# OXFORD PLANNING COMMISSION

## AGENDA

**April 13, 2025 – 7:00 PM**

1. **Opening** – Jonathan Eady, Chair
2. **\*Minutes** – Please consider for approval the minutes from the March 11, 2025 Planning Commission meeting. Please note, we did not meet in April.
3. **\*107 Oxford North Road:** Mr. Giovanni di Capo is requesting consideration for a Development Permit Application for the construction of a single-family home.
4. **Other Business:**
5. **Adjournment**

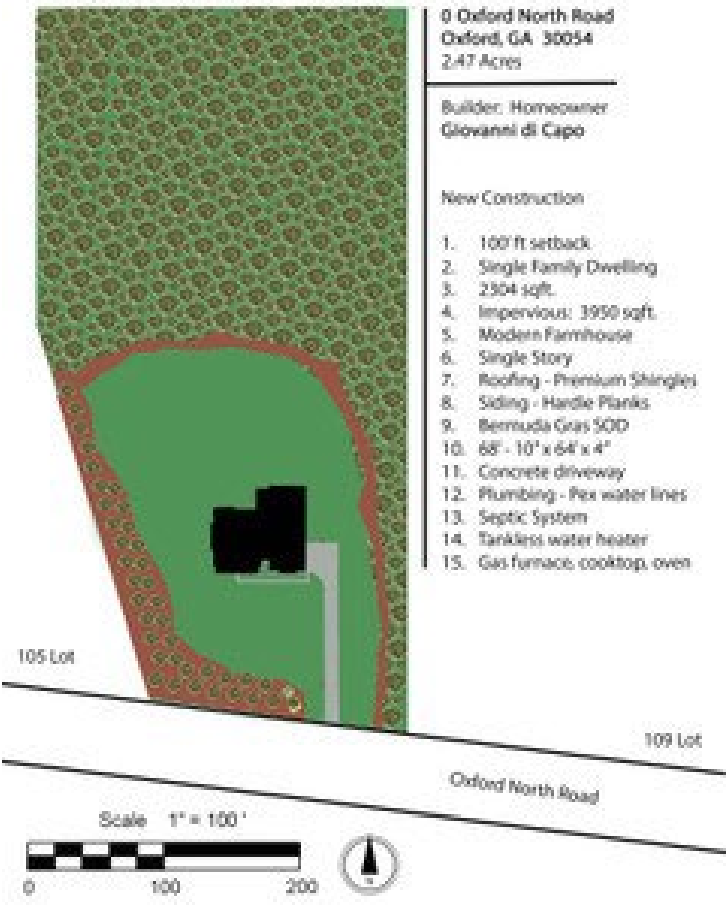
This is a home Mr. di Capo recently built in Conyers and is basically the same home he intends to build here. This house was 5 bedrooms and he intends to build 3 here.

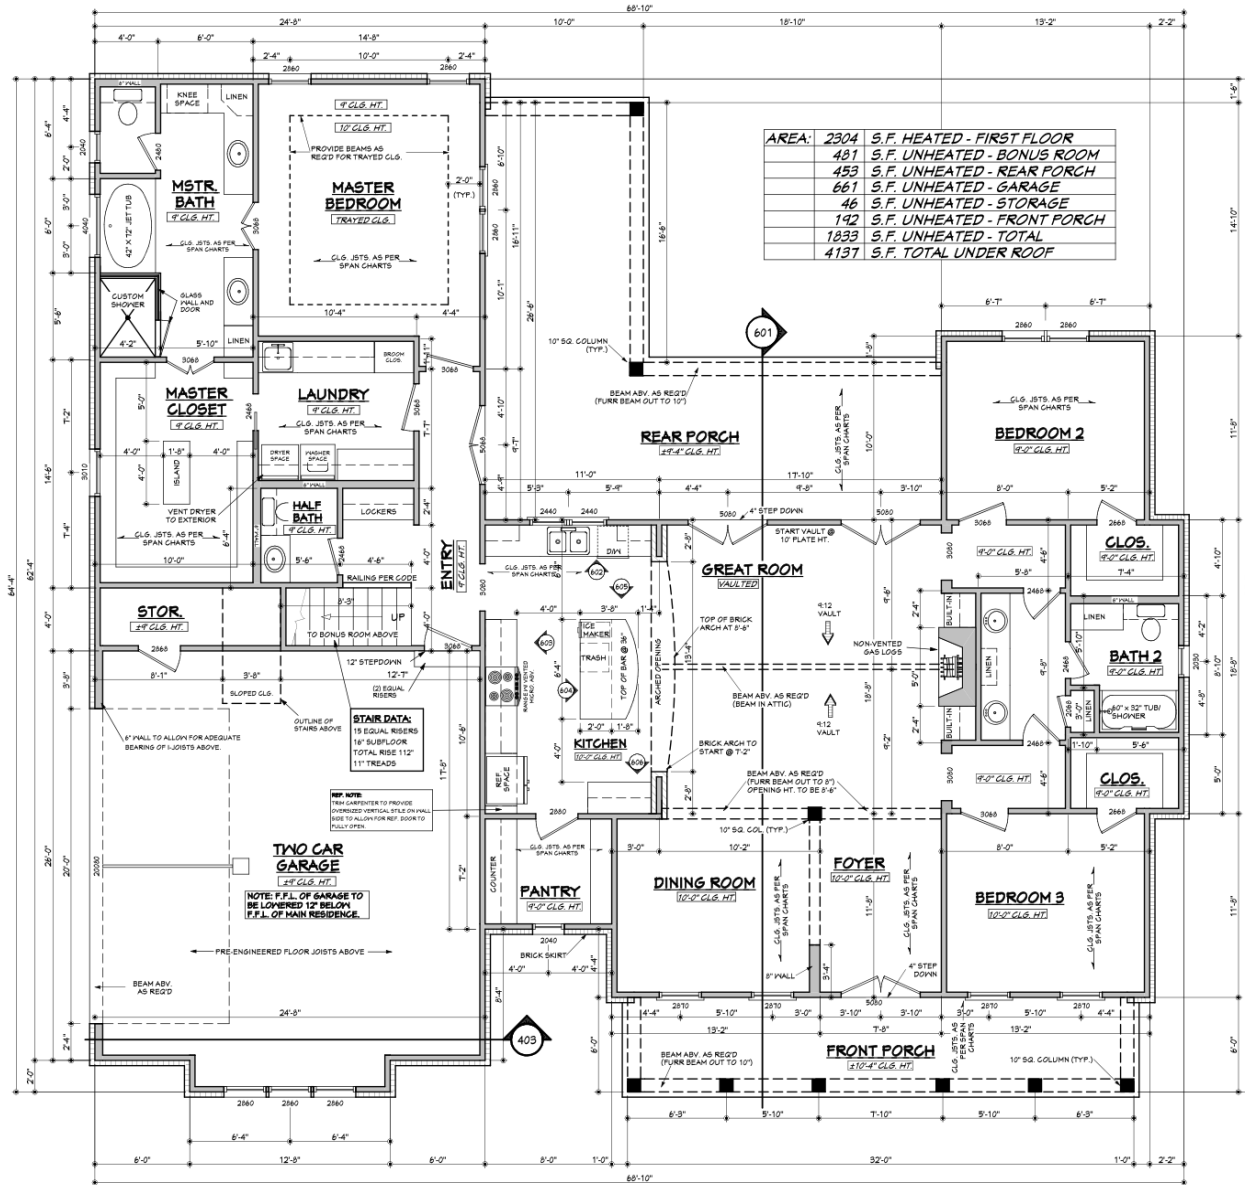
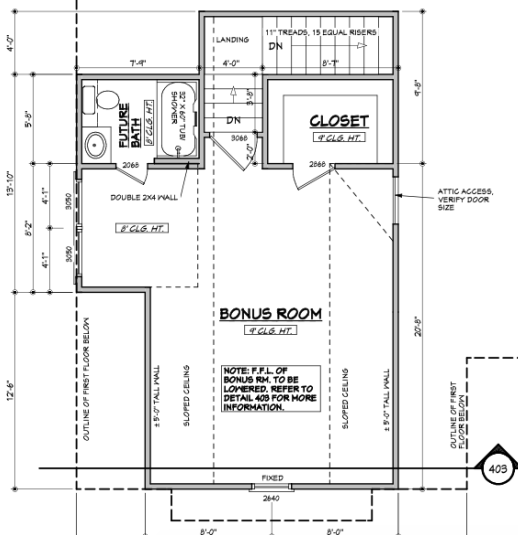
I was able to scale the map on my computer. Mr. di Capo and I agreed the home is setback 100 ft from the street, 75 ft from the western property line, 62.5 ft from the eastern property line, and 350 ft from the rear property line. The lot width at the building line is a little over 200 feet wide.

Rural Residential is not called out specifically in our tree canopy requirements, but I would think the R-30 requirements would apply and would require at least 40% of the lot remaining wooded. Both the layout and in emails, Mr. di Capo indicated this 40% requirement would be exceeded.
